Subject: Workplan Addendum
6310 Houston Place
Dublin, California
AEI Project No. 116304
Fuel Leak Case RO00002862

REVISED SITE PLAN

6310 HOUSTON PLACE
 DUBLIN, CA 94568

FIGURE 2
 Project # 116304

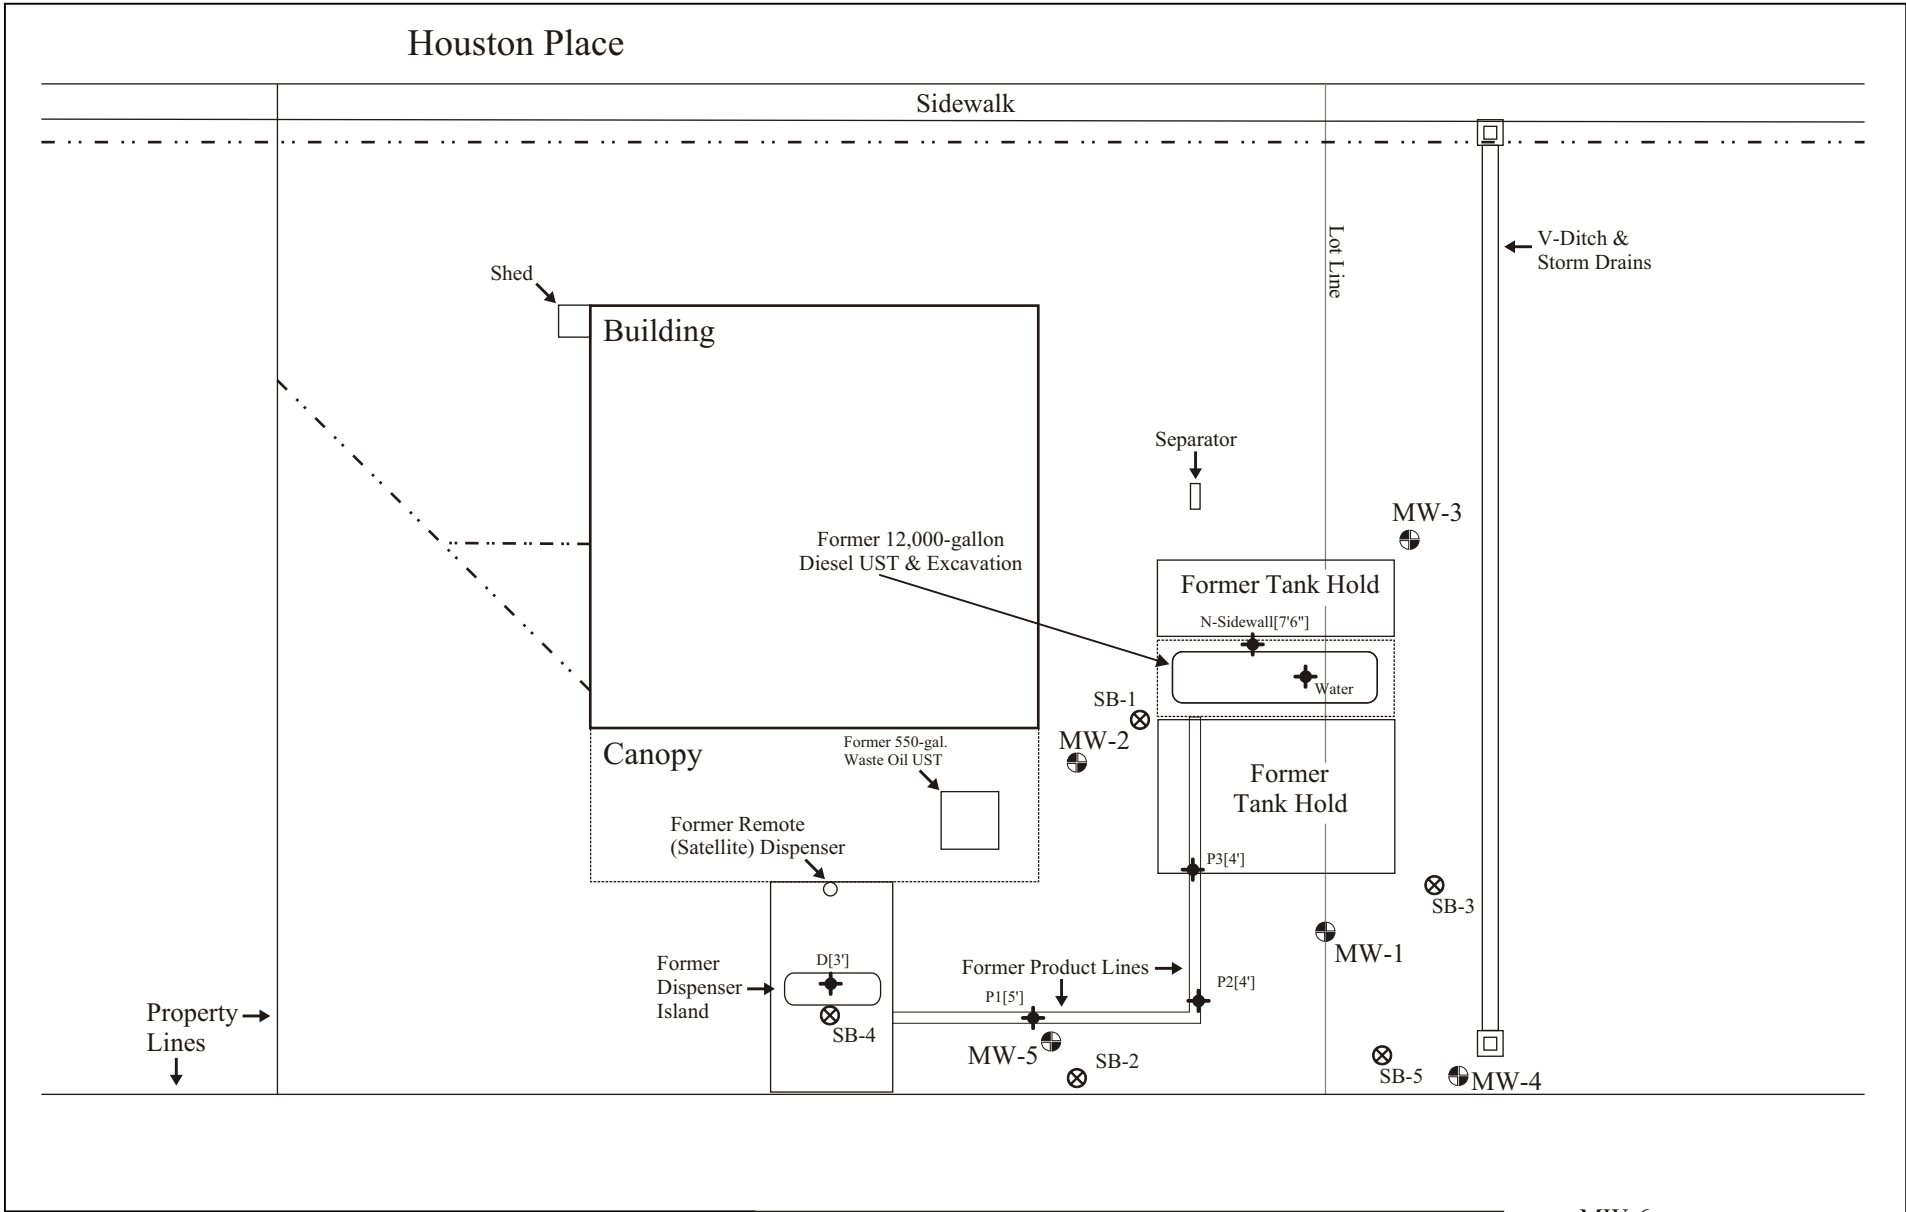
Attached is a revised site plan, with revised soil boring locations, per your comments. Several changes have been made to address those comments:

- Proposed boring SB-1 has been moved to just outside of the tank former tank hold, as requested, to between the tank hold and former monitoring well MW-2
- SB-2 was relocated to just southeast (down-gradient) of former well MW-5
- A fifth boring SB-5 was added to the scope of work, located south / southeast of former well MW-1, at the property boundary, to evaluate the extent of a release, if one occurred.
